SMITHFIELD IRRIGATION COMPANY
DIVERSION SYSTEM IMPROVEMENTS PROJECT
ADDENDUM #2

November 26, 2025

Smithfield Irrigation Company – Diversion System Improvements Project – Addendum 2

SITE PLAN

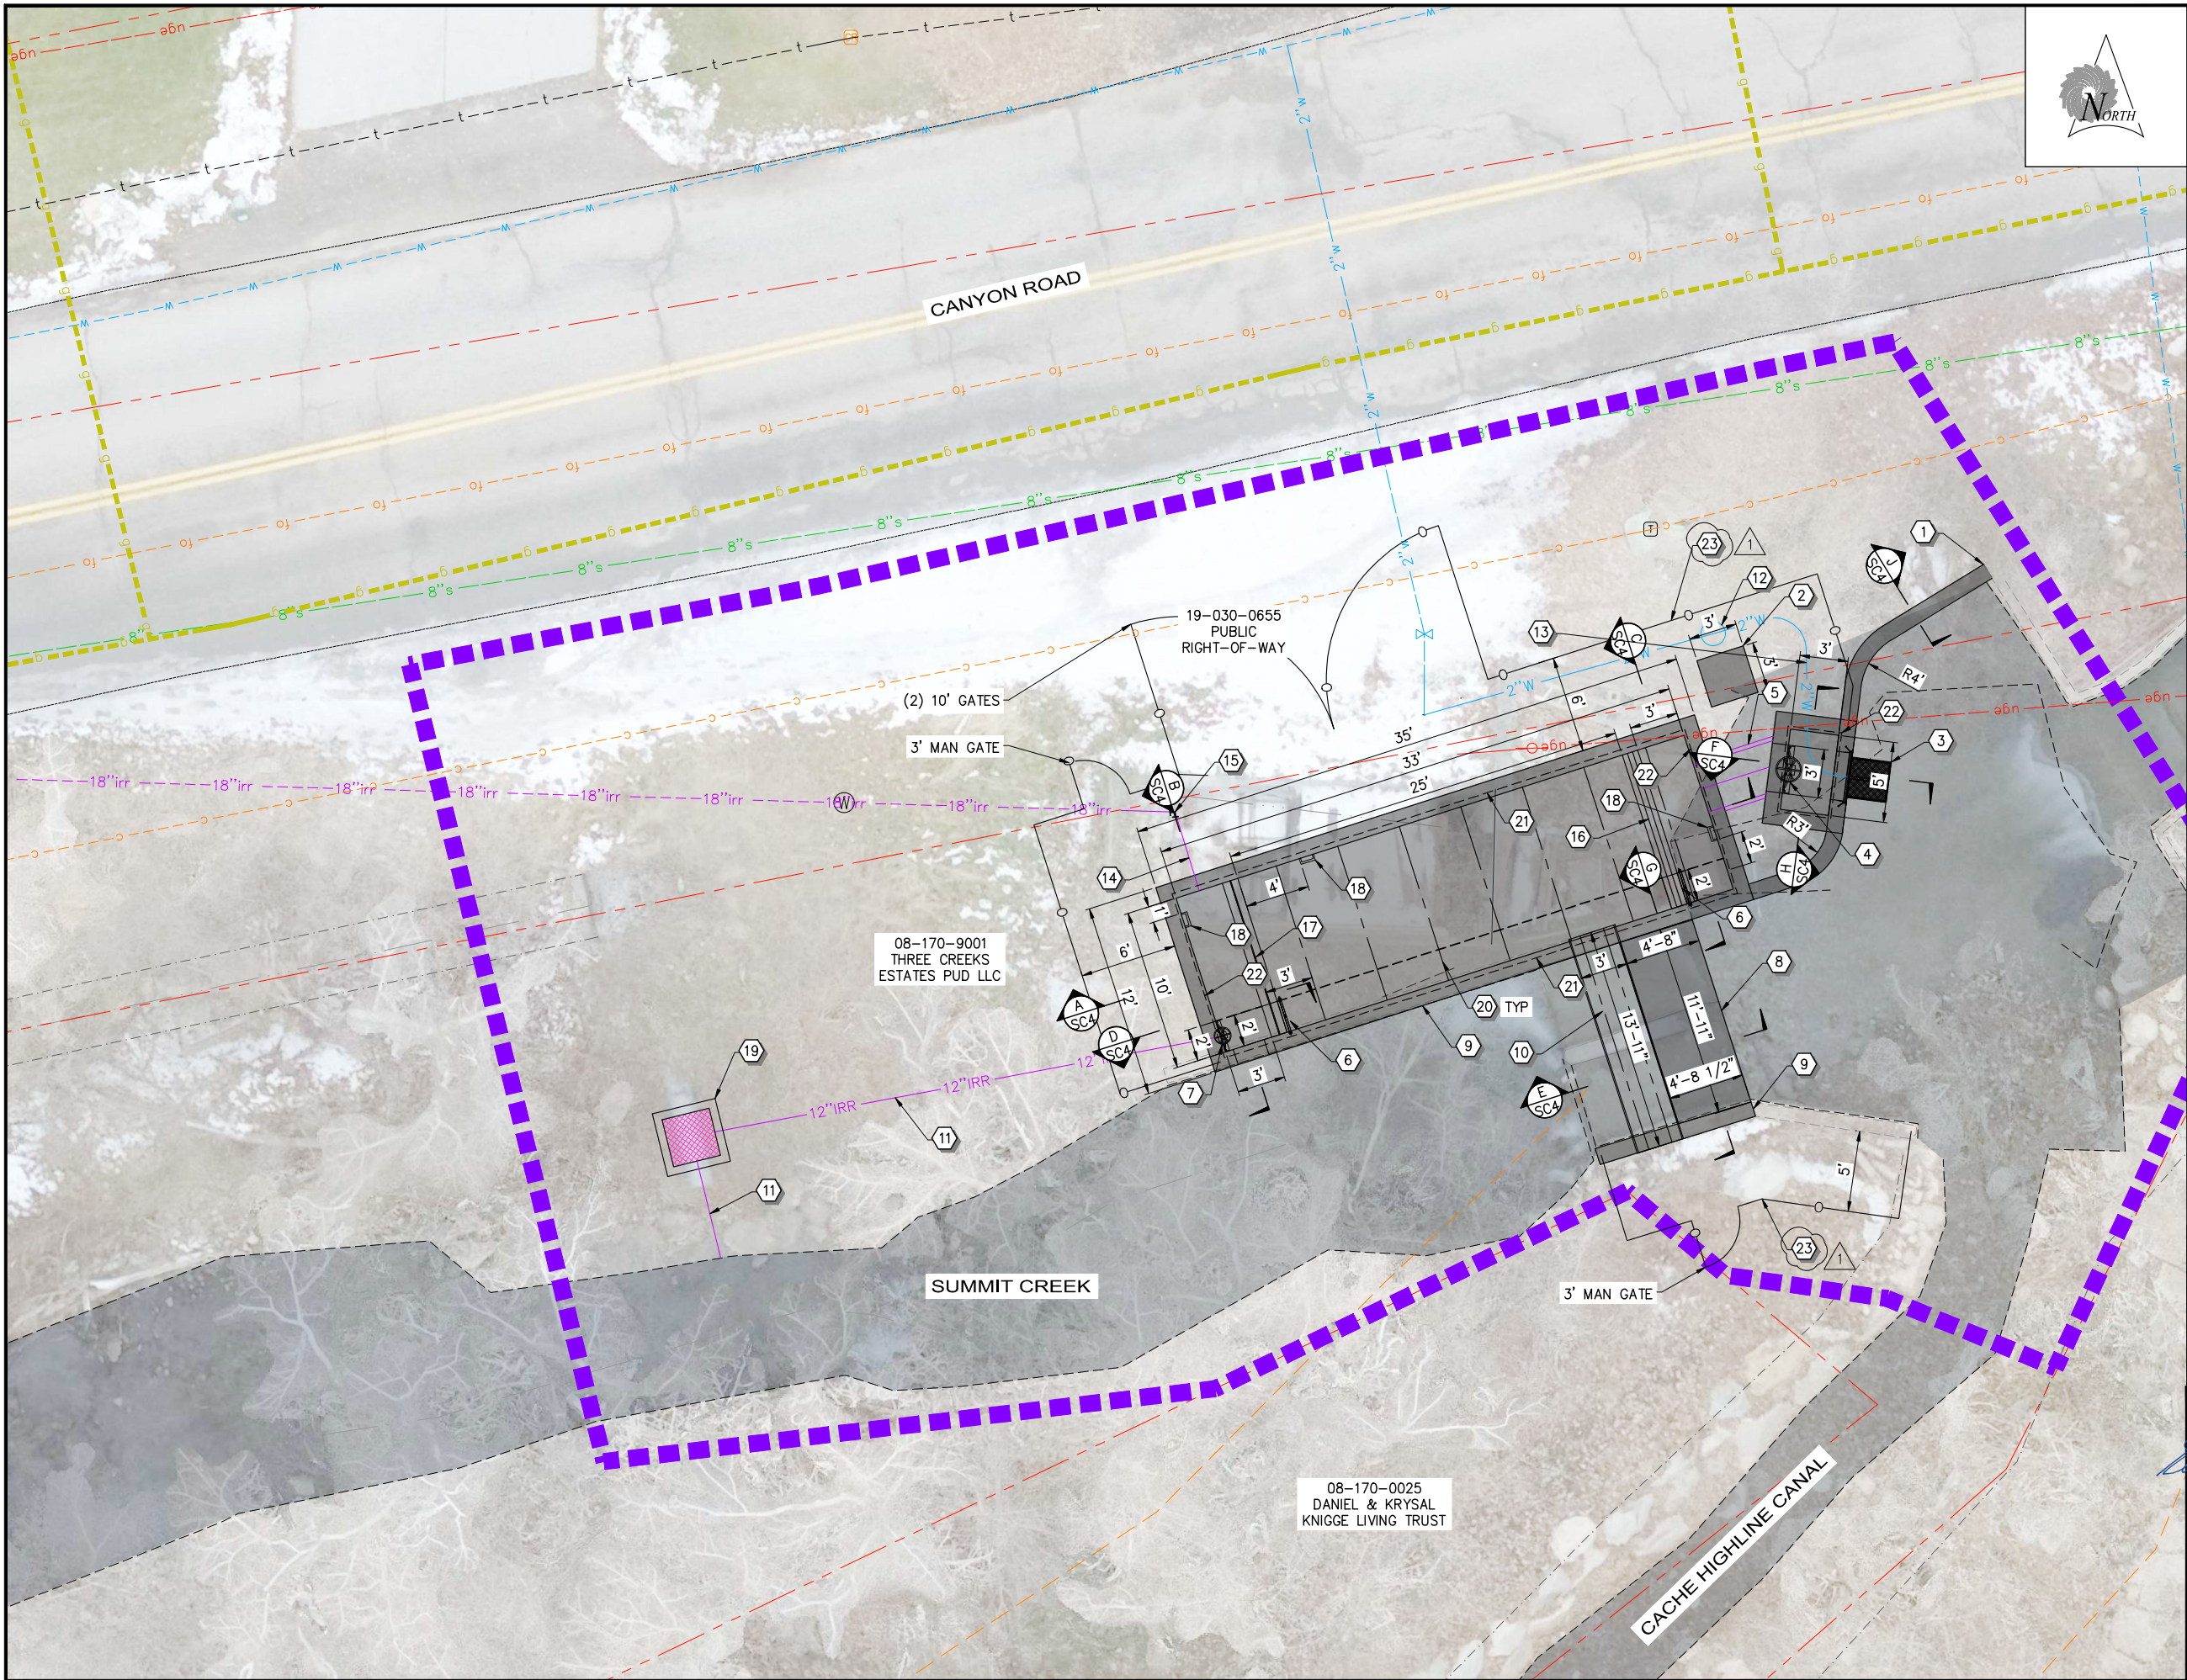
- Site Fencing has been added to SP4, SP5, SP6, and SP7

23. INSTALL 6' GALVANIZED CHAINLINK FENCE (A/D5)

SMITHFIELD IRRIGATION COMPANY
DIVERSION SYSTEM IMPROVEMENTS
BUDGE DIVERSION
SITE PLAN

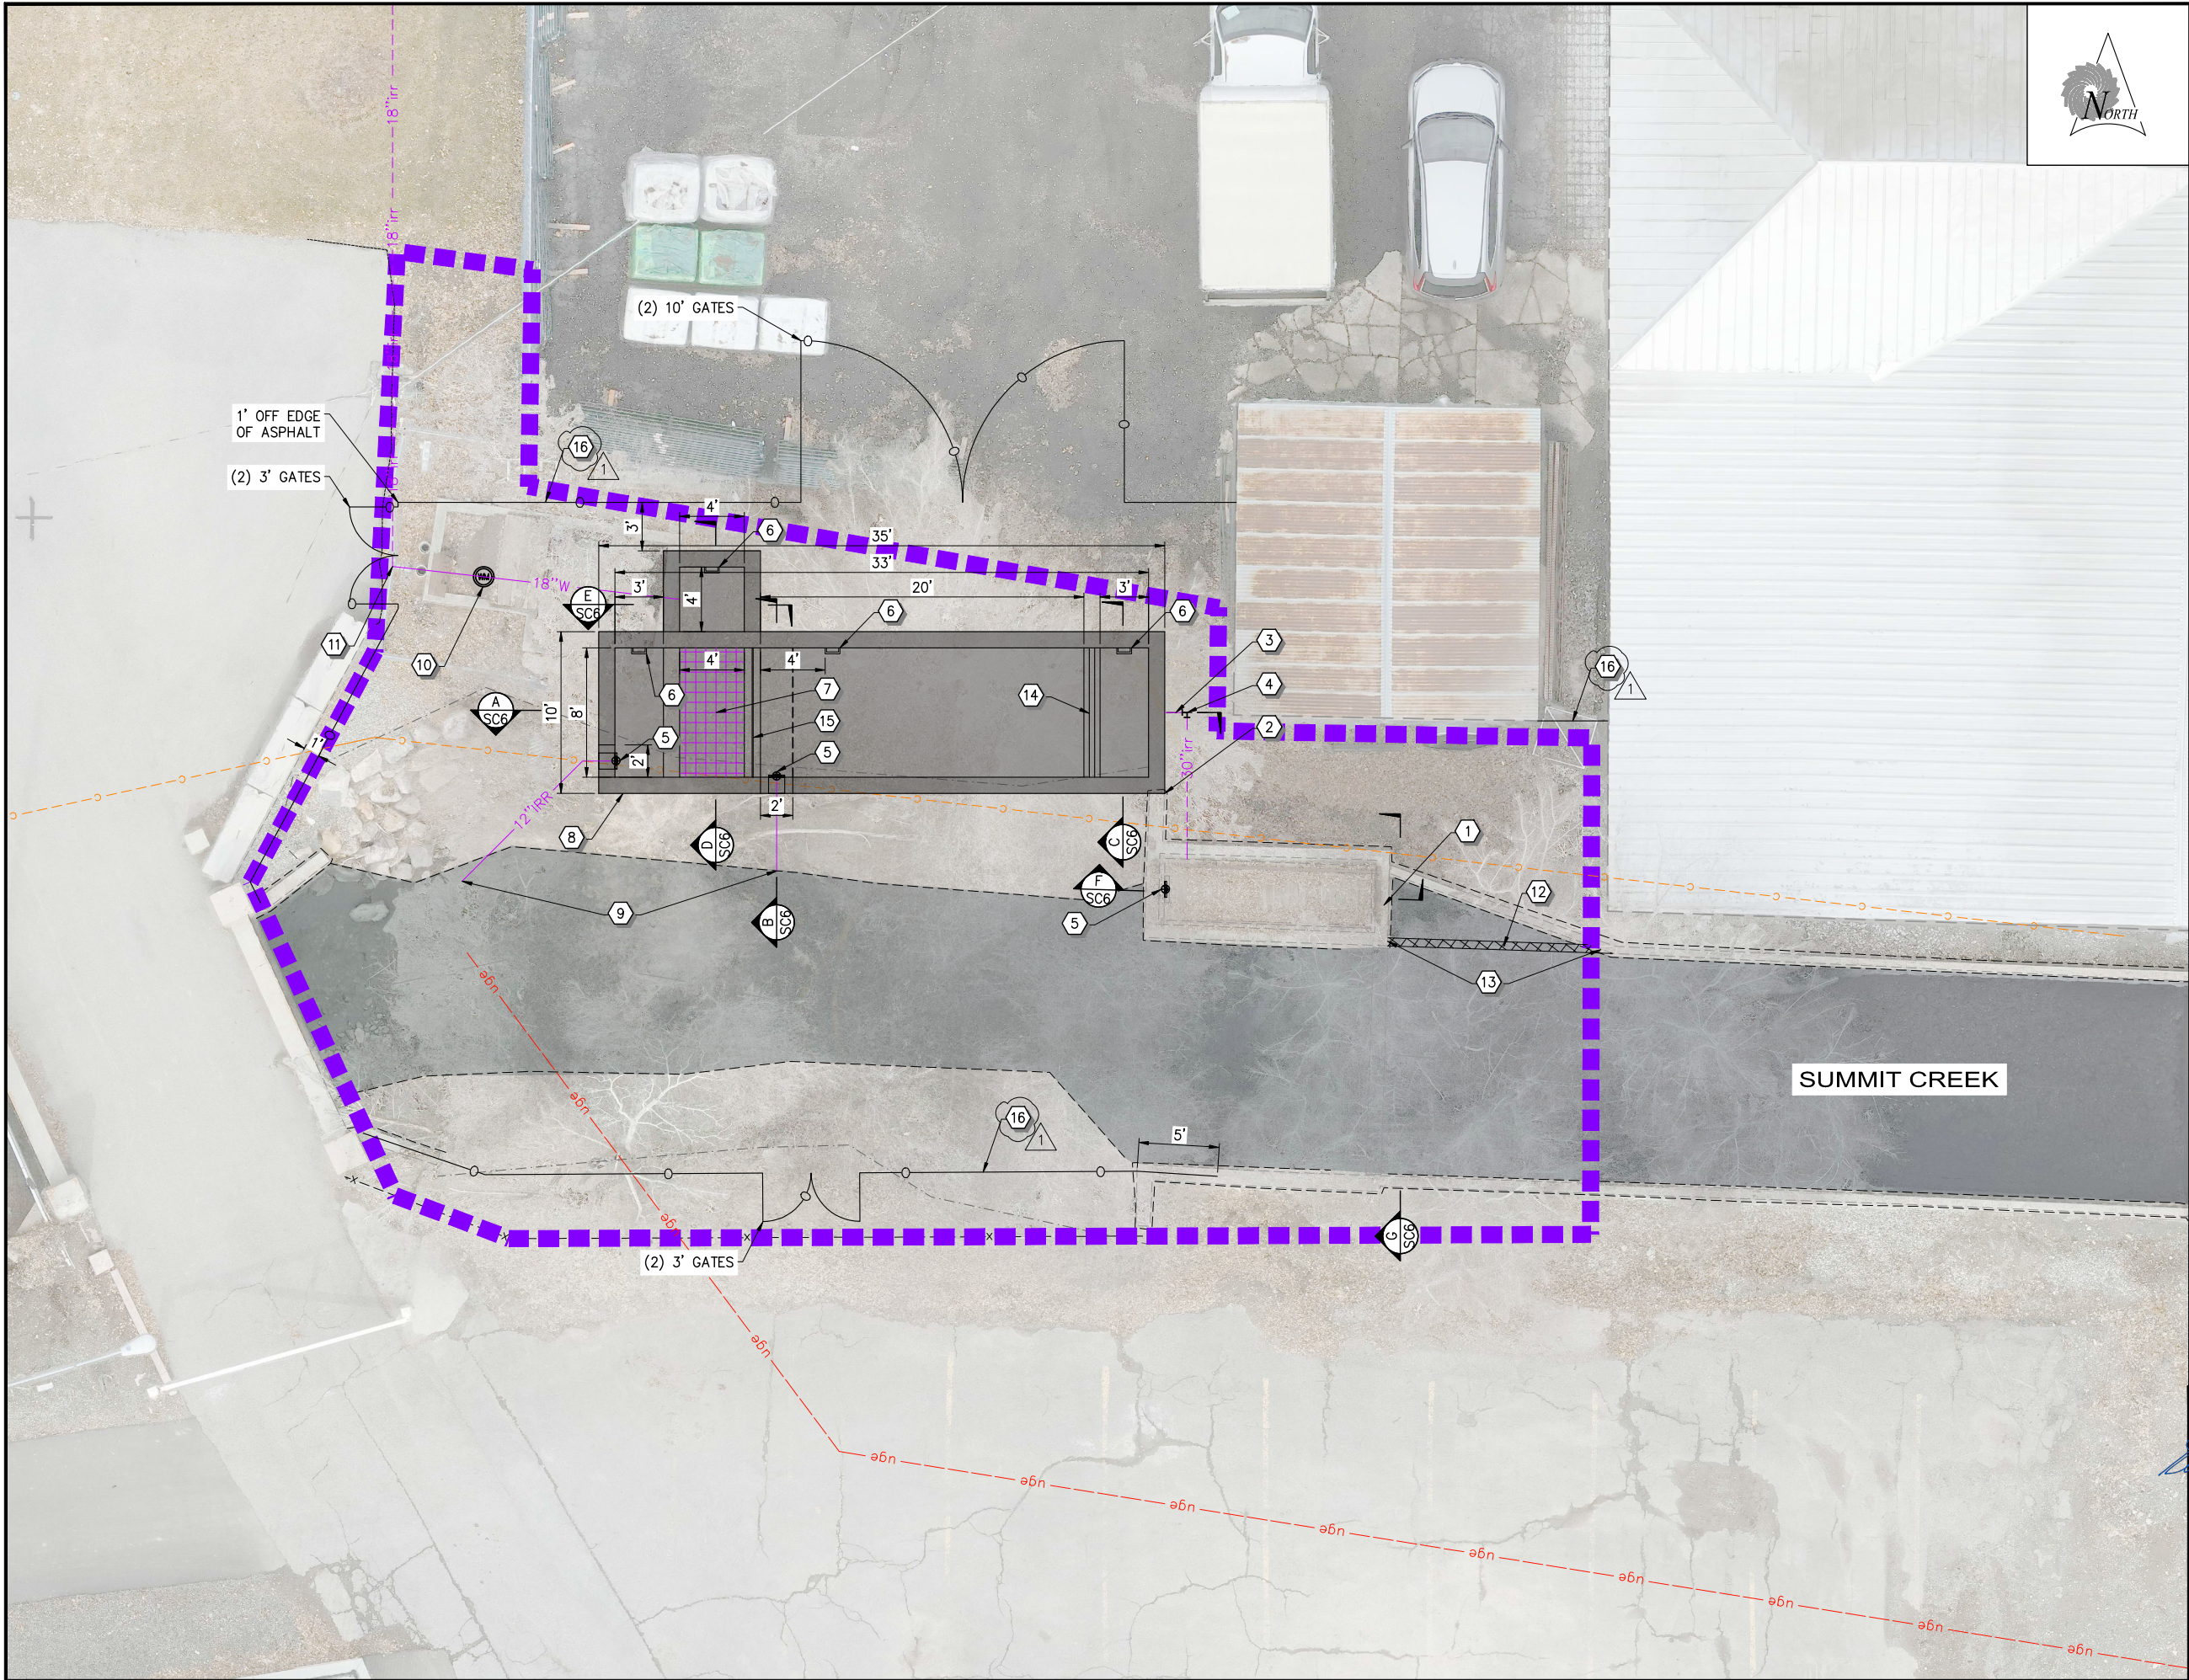
- 22 INSTALL MANHOLE STEPS @ 10" MAX SPACING
- 23 RELOCATED EXISTING PEDESTRIAN BRIDGE
- 24 INSTALL FITTING PER PLAN
- 25 INSTALL 6' GALVANIZED CHAIN LINK FENCE (A D5)

SMITHFIELD IRRIGATION COMPANY				
DIVERSION SYSTEM IMPROVEMENTS				
CLAY POOL SOUTH DIVERSION				
SITE PLAN				
SET NO.	DESIGNED	DRAWN	CHECKED	SHEET NO.
12499	HP	JJ	SDW	29 of 61
				SP6

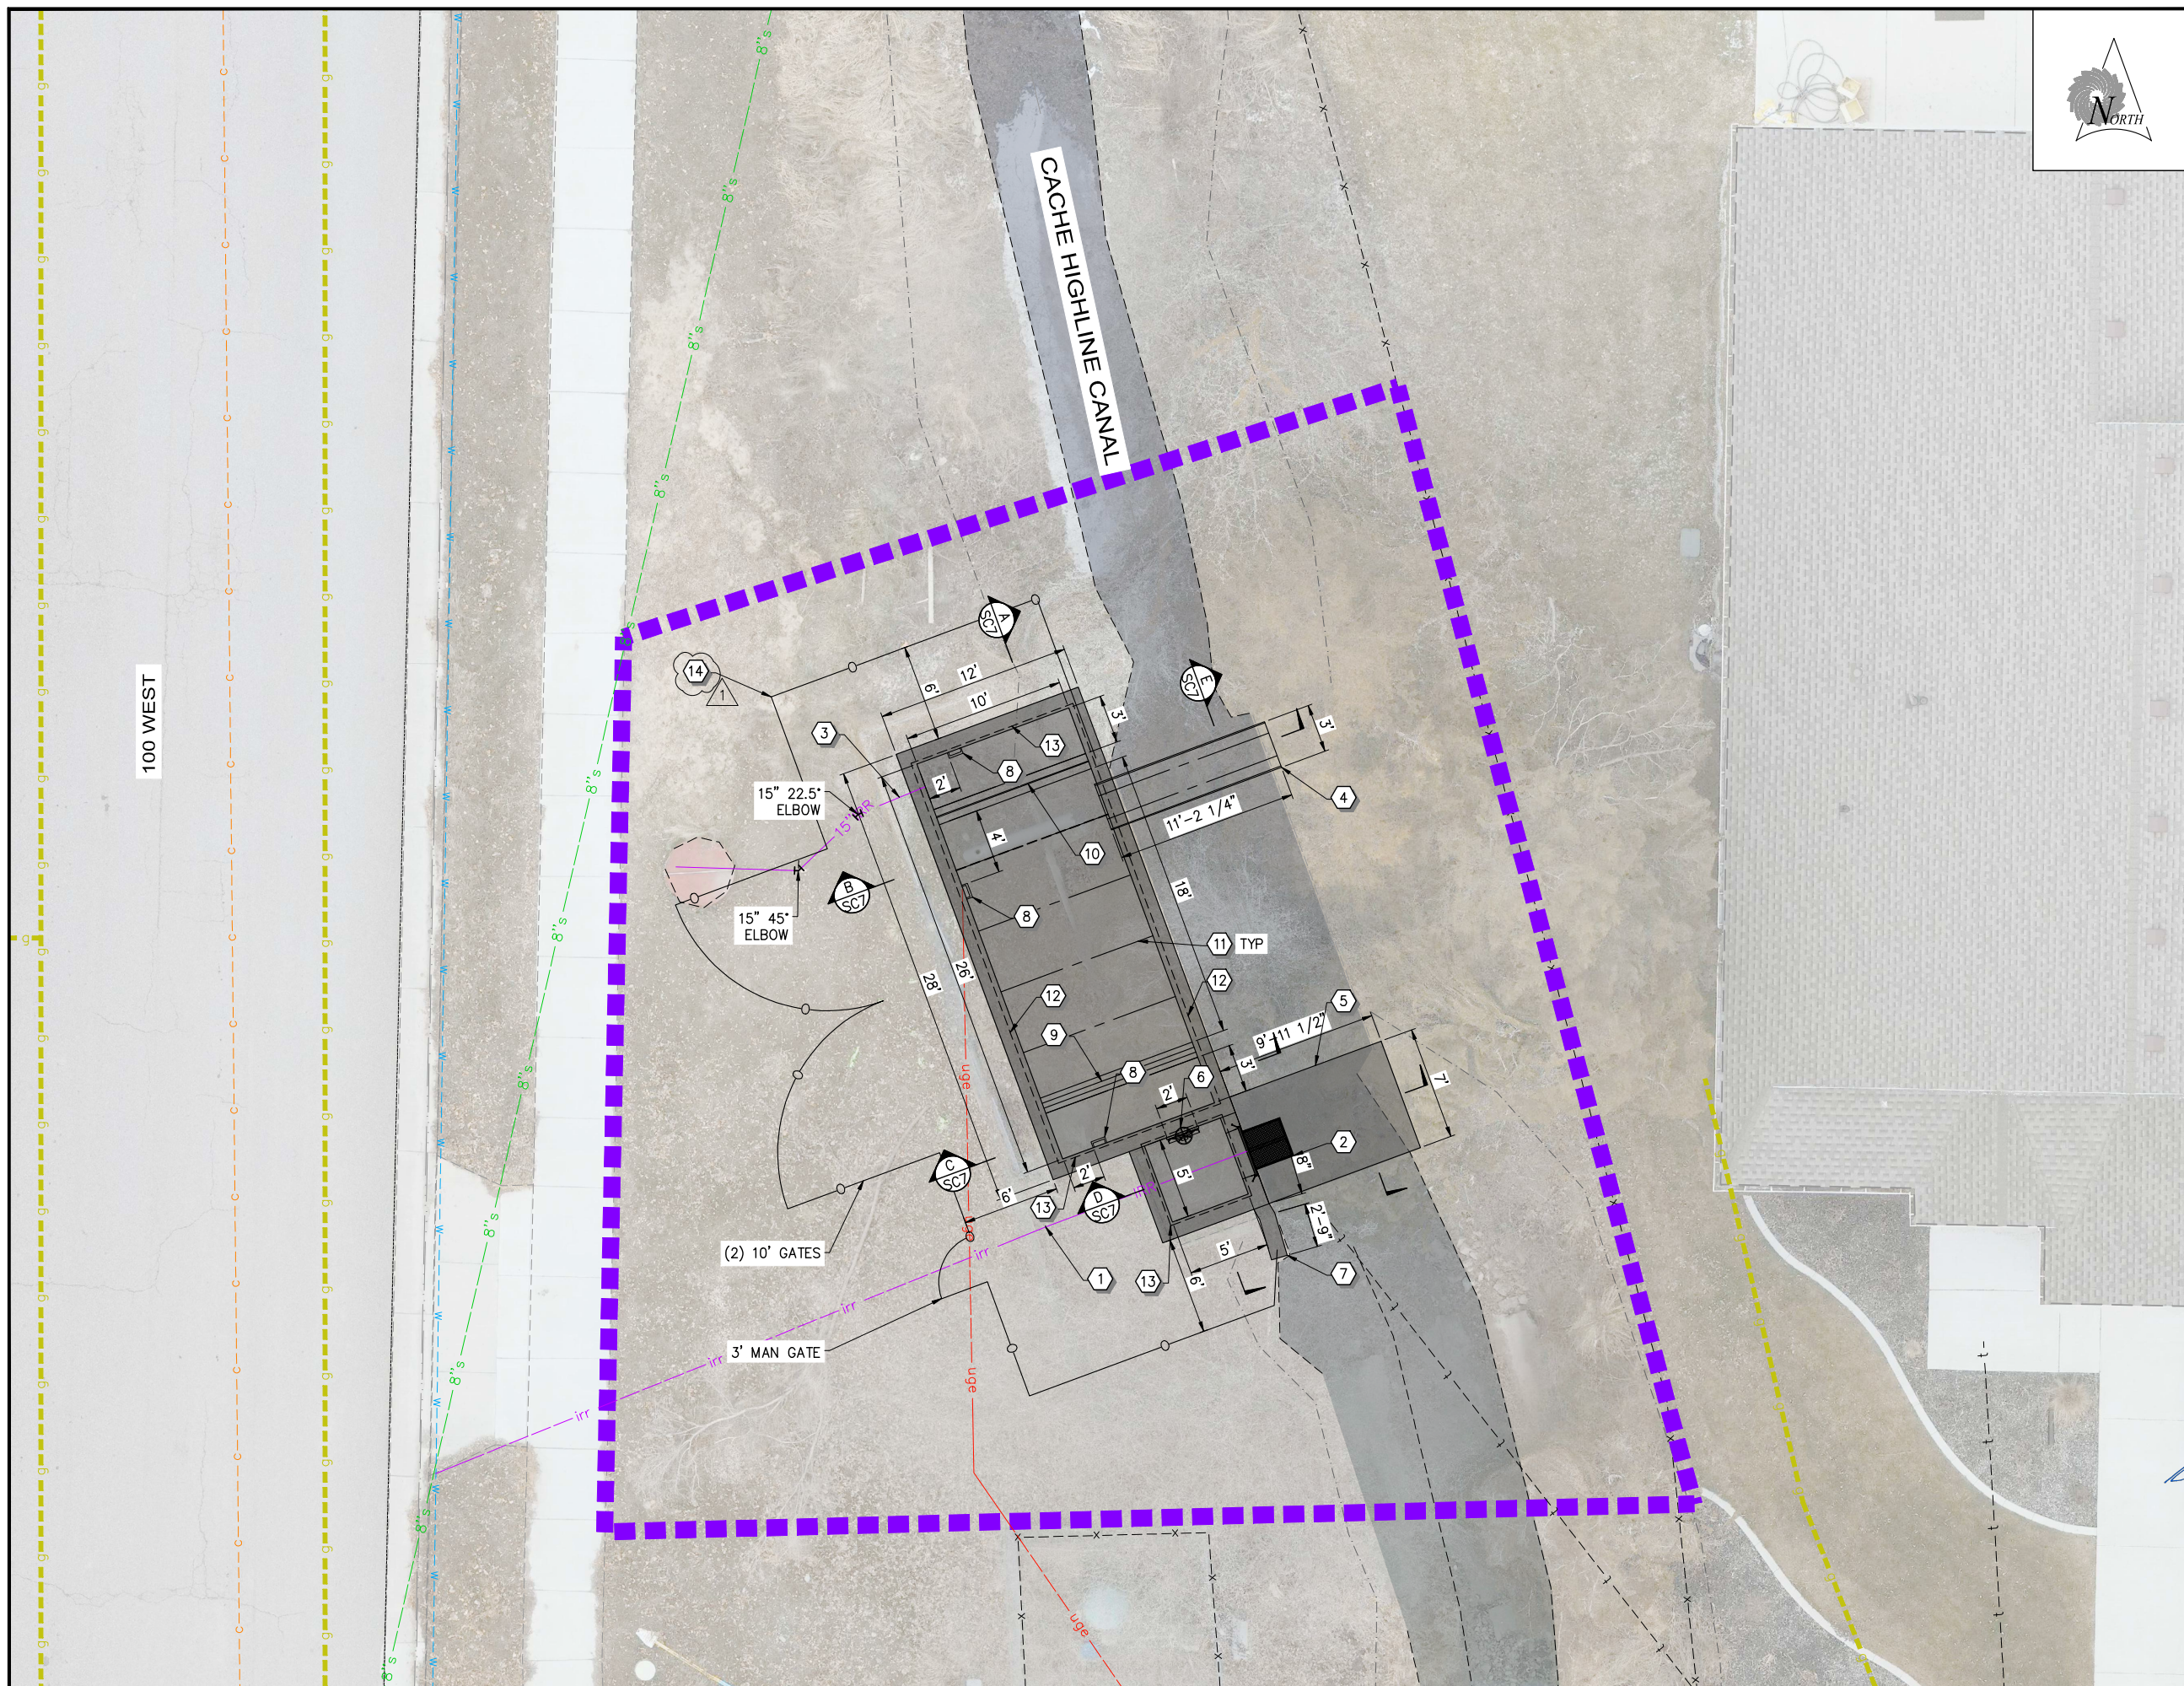
- ### CONSTRUCTION NOTES
- 1 EXISTING UNDERSHOT GATE
 - 2 LOCATE NEW STRUCTURE AGAINST EXISTING WALL
 - 3 INSTALL RE-USED 30" INLET PIPE - PIPE IS TO BE CAST INTO NEW CONCRETE STRUCTURE
 - 4 INSTALL RE-USED 30" 90° ELBOW
 - 5 INSTALL 12" HEADGATE (K SC2)
 - 6 INSTALL MANHOLE STEPS @ 10" MAX SPACING
 - 7 INSTALL WEDGE WIRE SCREEN (M SC2)
 - 8 INSTALL RECESSED RECTANGULAR WEIR
 - 9 INSTALL 12" PVC PIPE - MAINTAIN NEGATIVE GRADE TOWARD CREEK
 - 10 INSTALL METER MANHOLE (B, C D1)
 - 11 INSTALL 18" C900 PVC PIPE AND CONNECT TO EXISTING PIPELINE (D D1)
 - 12 INSTALL COARSE BAR SCREEN
 - 13 INSTALL C CHANNEL
 - 14 INSTALL INFLOW WEIR
 - 15 INSTALL OUTFLOW WEIR
 - 16 INSTALL 6' GALVANIZED CHAIN LINK FENCE (A D5)
